Peer Review of

ESTATES OTAIHANGA SUBDIVISION PROPOSAL LANDSCAPE and VISUAL IMPACT ASSESSMENT

DCM Urban Design Limited

For: Kapiti Coast District Council

Figure 1 Comparison of DCM VP9 Pitoittoi St and Reviewer VP10 from end of Pitoittoi St

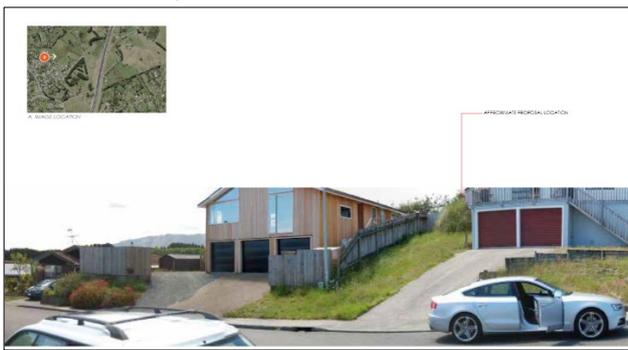
- VP1 better represented effects on residents in small farmlets to west of site. VP1 has limited value in assessing visual effects⁸
- VP9 Pitoittoi Street provides limited information. Reviewer proposes another location at the end of Pitoittoi Street shown in Figure 1 below.
